SITE INSTRUCTION

SI A25 R

PROJECT : Forestside
PROJECT # : 1331.15
DATE : Mar. 24, 2023

Title: Revisions to plans as itemized.

1:50 A-304a1

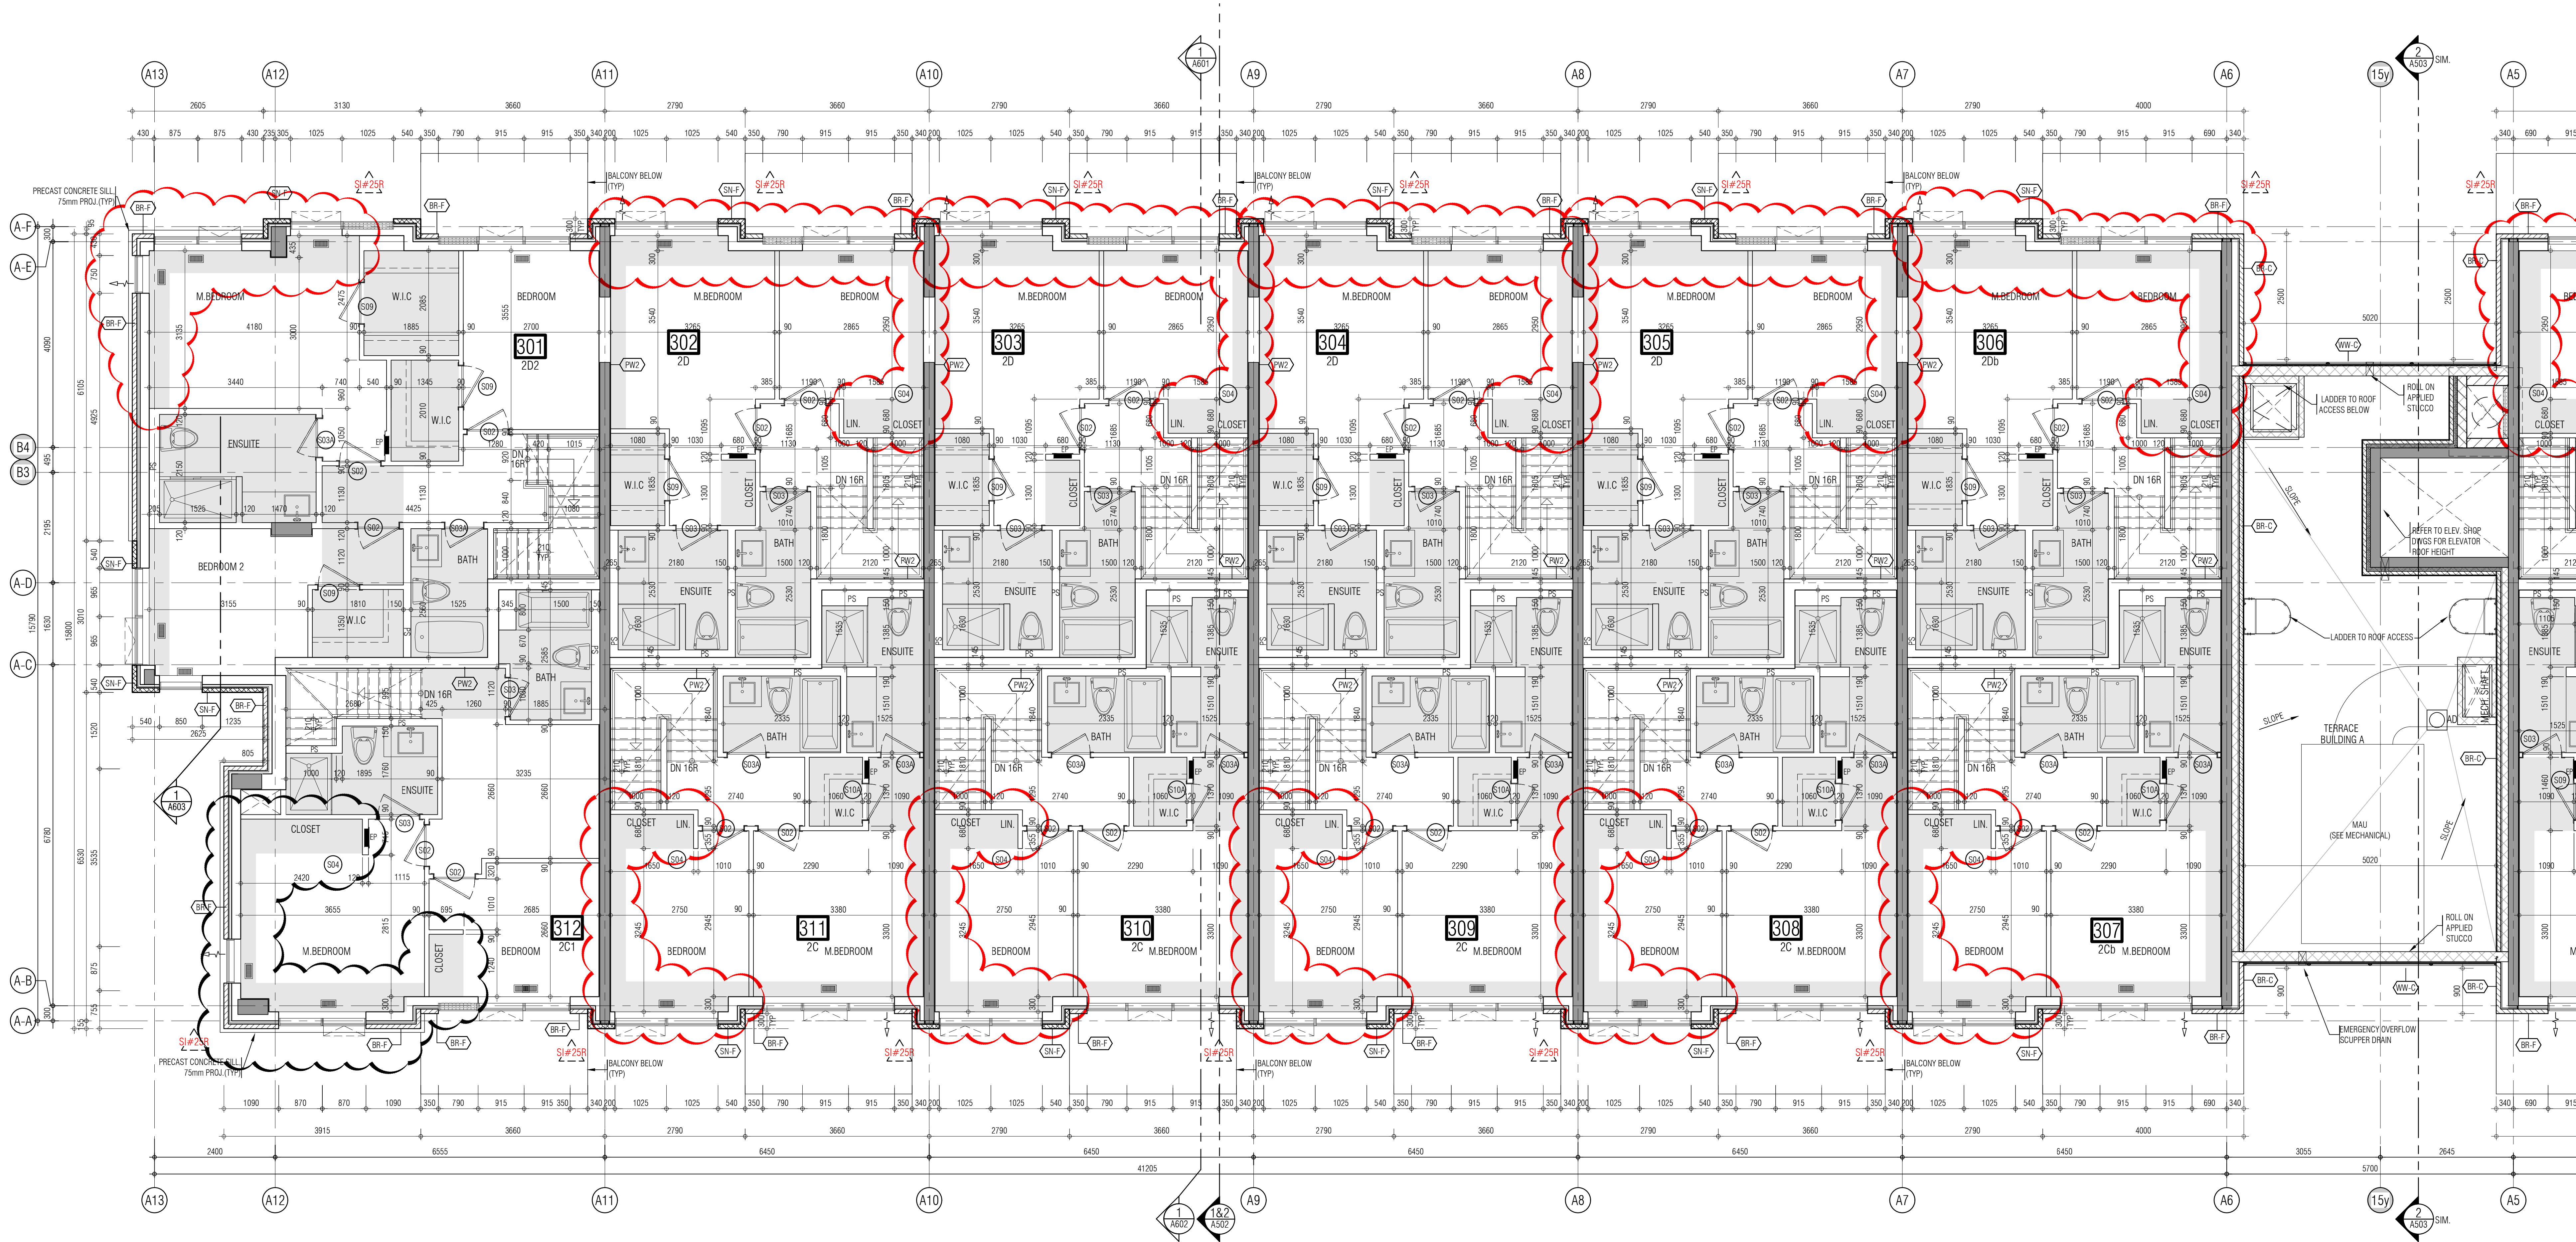
Reference:		Changes:
A304a-A304d	4th Floor Plans	Add bulkheads to plans as per mechanical coordination of HVAC Layouts. (Refer to SI.M.6)
